06 June 2023

PPC Application – Clause 23 Requests from Auckland Council including Further Information Requests

Applicant: Aedifice Development No.1 Limited  
 Address: 47 Golding Road and 50 Pukekohe East Road, Pukekohe  
 Proposed activities: PPC – Pukekohe East-Central Precinct 2

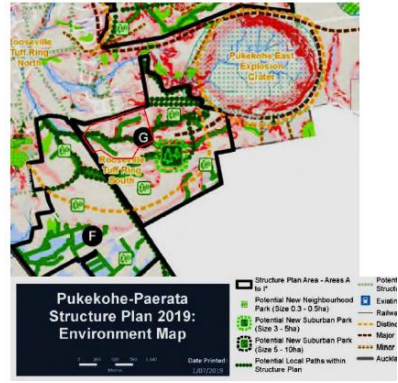
#	Category of information	Clause 23 Specific Request (19/09/22)	Reasons for Request	Applicant Initial Responses (30/09/22 and 07/03/23)	(Clause 23 (2)) Councils Further Requests Arising from Applicant Responses (16/03/23)	Applicant Responses to Further Requests
			<p>The map (above) (reasons for requests) shows the <b>revised</b> locations of open space across the Pukekohe-Paerata Structure Plan area based on a service needs gap analysis.</p> <p>This supersedes the indicative locations shown in the structure plan. The neighbourhood park is no longer required between Golding and Ngahere Road. The existing open space (Roosevelt Park; approx. 11.4ha) meet council open space provision targets for that area, particularly a neighbourhood park within 400m walking distance for that area and so the gap location has been demonstrated to the north west, within this particular precinct plan.</p> <p>There is a gap within the open space provision policy to adequately secure the provision of a neighbourhood park for future communities that will meet the open space provision policy.</p> <p>The reason why we say it must meet open space provision policy is threefold:</p> <ol style="list-style-type: none"> <li>1) to make sure the park demonstrated is more or less of the location and standard that enables council to acquire that land for the communities in the future.</li> <li>2) ensure any developer in the future secures the provision of this open space as part of their development that will enable them to demonstrate meeting open space provision policies as required under both the NPS-UD and underlying AUP zoning Policies.</li> <li>3) The location of such a park (3-5ha) can have a spatial effect on the master planning of any new development that affects road layouts, access etc.</li> </ol> <p>The “passive public open space” as demonstrated on the precinct plan does not meet open space provision policy in terms of shape size and accessibility.</p> <p>We require a neighbourhood park located more centrally within the precinct plan, that can be fronted by a minimum of two roads to meet the gap within the open space provision policies</p>
